RE: SAFETY INFORMATION

This potential safety issue update concerns KLEEMANN traction lifts utilizing a UControl inverter/drive.

Upgrade Procedure

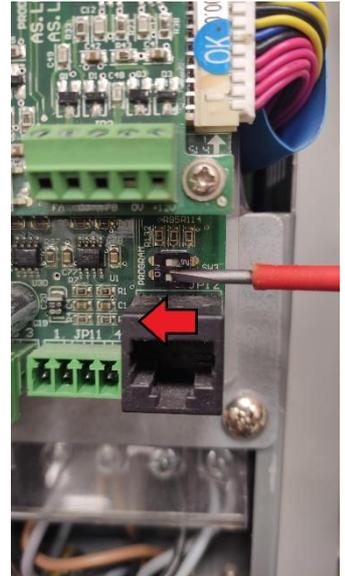
13. Activate the **SW3** dip switches by moving them to “**ON**” position (see picture).
14. Disconnect the USB cable from the Ucontrol hand terminal and connect the provided programming keypad to the USB cable.

Pay attention if there is any accumulated dust inside the inverter specially in the **SW3** area. Before performing step 13 make sure that the inverter is completely turned off, wait at least for 20 minutes in order to have a complete discharge of the inverter capacitors and with a dry cloth lightly wipe any dust on the dip switches. If there was dust and after it was cleaned, operate (ON-OFF-ON) the dip switches 2-3 times. In case the dip switches are not operating properly due to dust, after step 19 "**progress report connection fail**" will appear on the screen.
